## Memo

**From:** Plan Review Committee of the Verona Environmental Commission

**Date:** August 3, 2022

**Re:** **Case # 2022-04: Major Development**  
1 Sunset Avenue [Block 303, Lot 4]  
Verona, New Jersey

SANITARY SEWER CO-1 TO DOGHOUSE MH-11

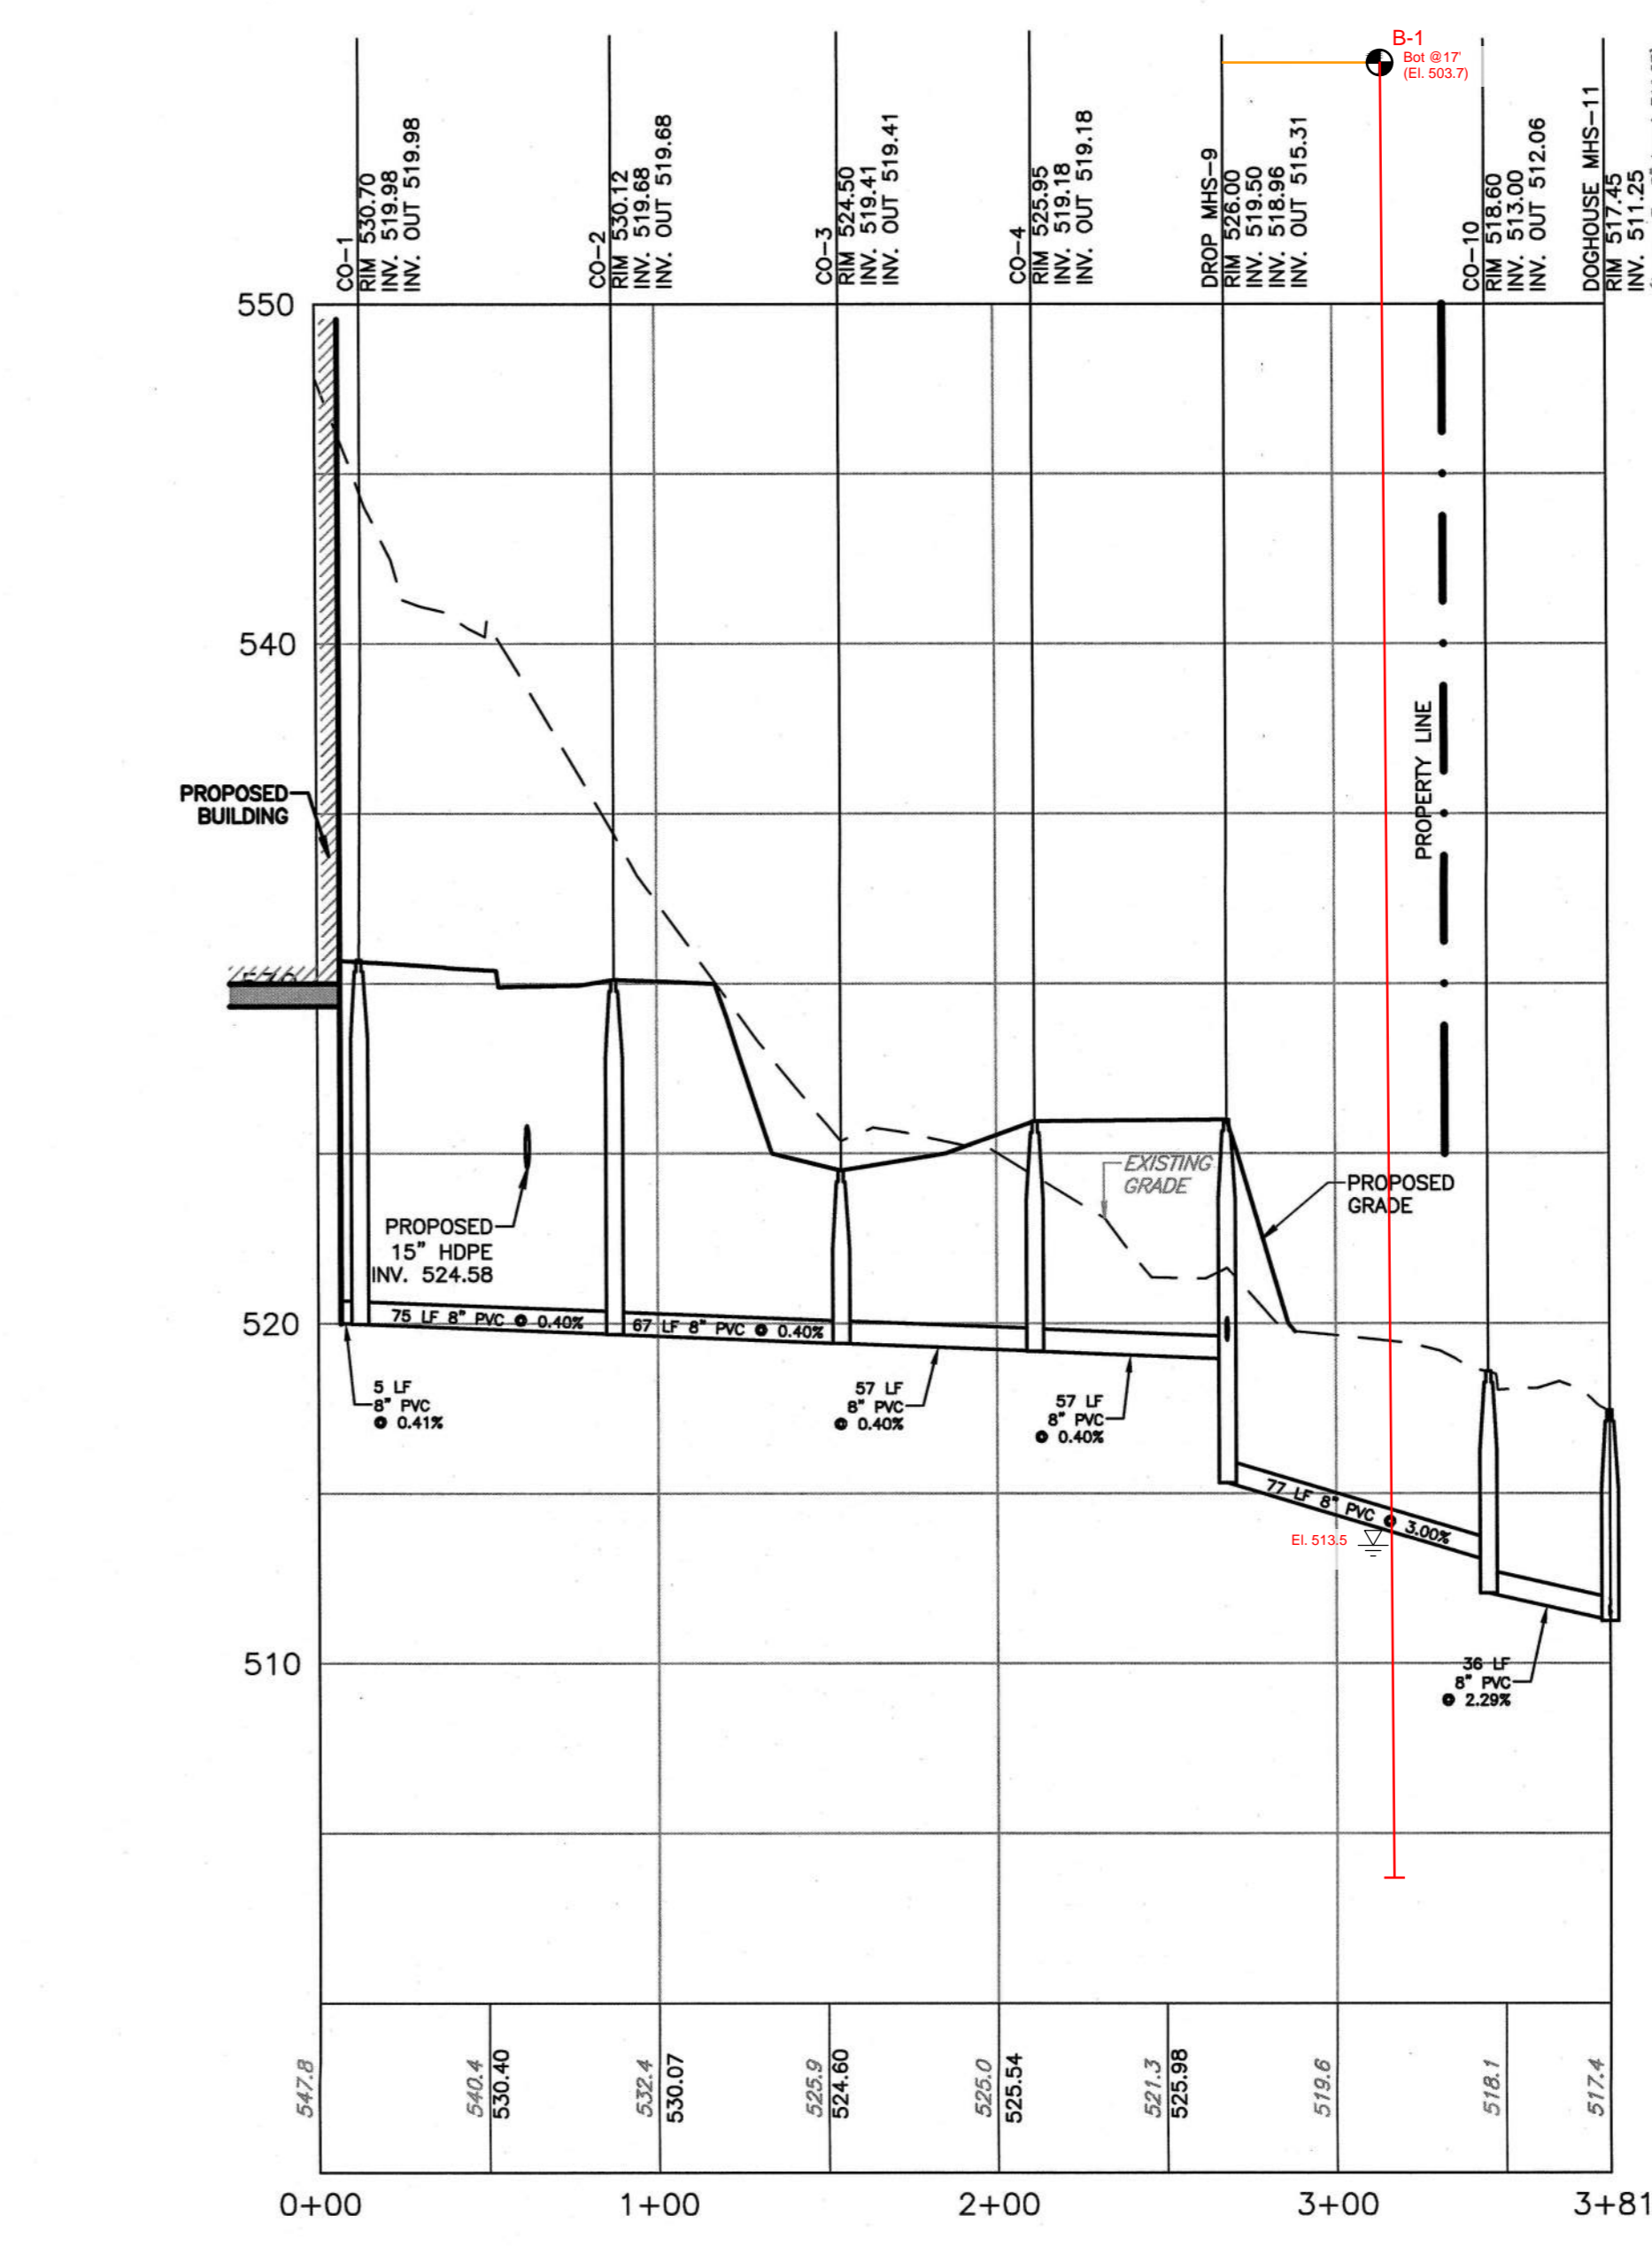
2. There were only six subsurface explorations provided in the application and we understand bedrock is very shallow at this site, which can be very problematic for all structures and utilities that are designed to be below top of rock elevations (as depicted in attached Sheets 7 and 8 annotated by the VEC). Bedrock was encountered in five of the six test borings with depths ranging from 2 to 9 feet below existing grades. NJ Building Code §1803.3.1 requires a minimum of one exploratory test boring to rock for every 2,500 ft<sup>2</sup> of built-over area; base on the size of this development we would expect a minimum of 432 test borings be documented or a justification from the Applicant's engineer as to why the minimum number was not completed.
